Errata and Added Information to **MC68360 Quad Integrated Communication Controller User's Manual Rev 1**

January 8, 1998

This document describes the latest information and changes to the first revision of the MC68360 user's manual.

Figure 6-6A External Components for 4.192MHz

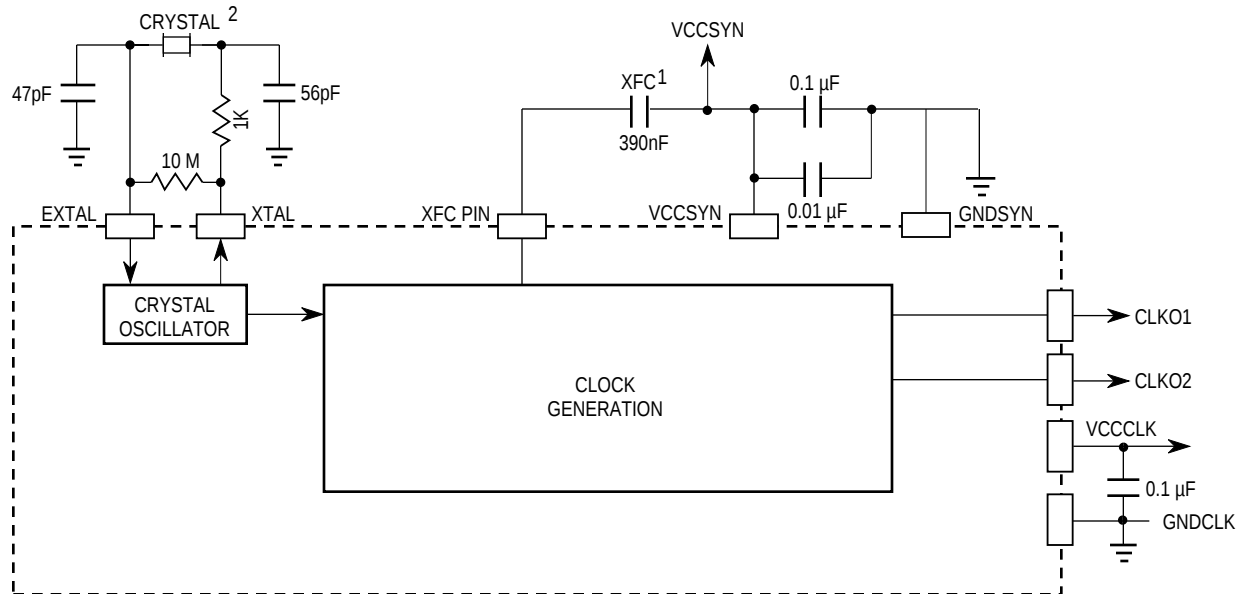
Also on page 6-14 the following figure should be added.

1. Must be low-leakage capacitor. See Section 10 Electrical Characteristics for recommended values.
2. Values are for 4.194MHz crystal and may vary due to capacitance on PCB.

Figure 10-44(a). MC68040/EC040 SRAM Read Cycles (TSS40=0, CSNT40=1)

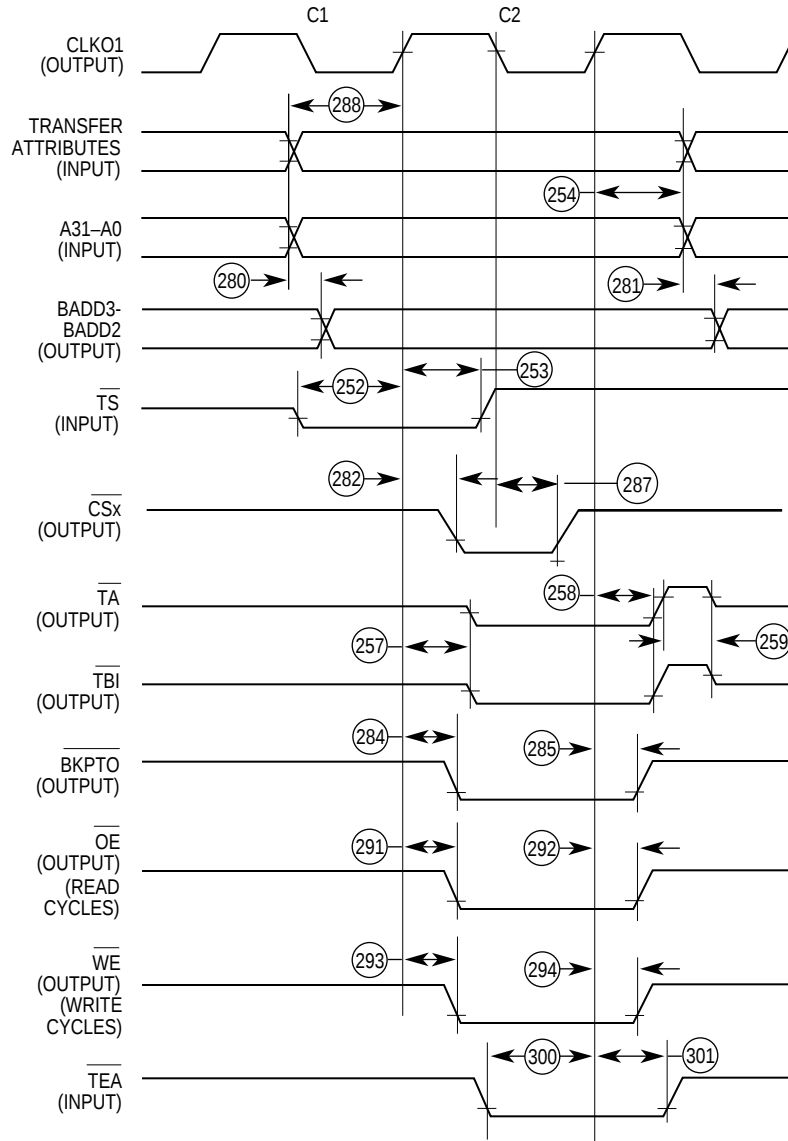
On page 10-57 the figure title should be replaced with the following

The following figure should be added after figure 10-44(a)

Figure 10-44(b) MC68040/EC040 SRAM Write cycle (TSS40=0, CSNT40=1)

Figure 10-45(a) MC68040/MC68EC040 SRAM Write cycle (TSS40=1, CSNT40=1)

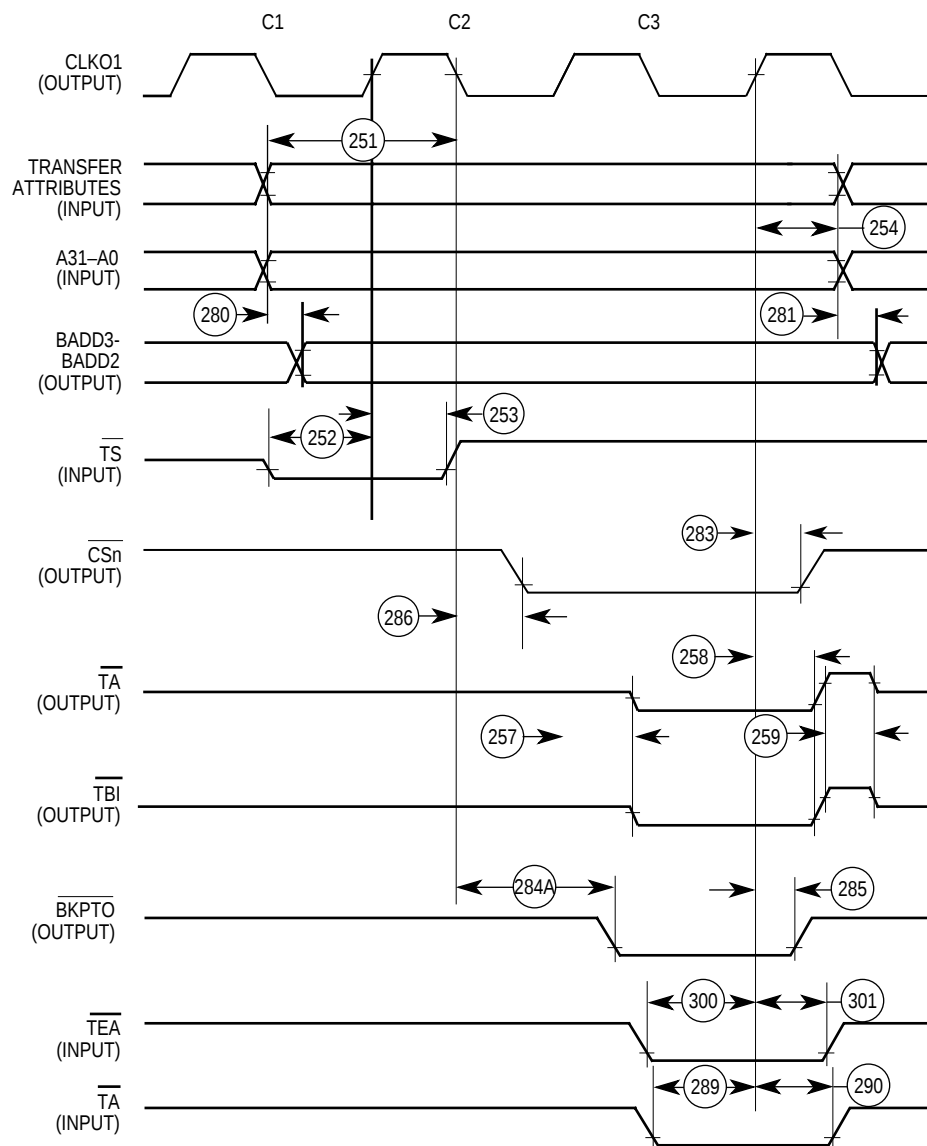
On page 10-58 the figure title for FIGURE 10-45 should be replaced with the following.

NOTE

$\overline{OE}$ and $\overline{WE}$ signals are not supported when TSS40 is set to 1.

The following figure should be added below figure 10-45(a)

Figure 10-45(b) MC68040/EC040 SRAM Read Cycle (TSS40=1, CSNT40=1)
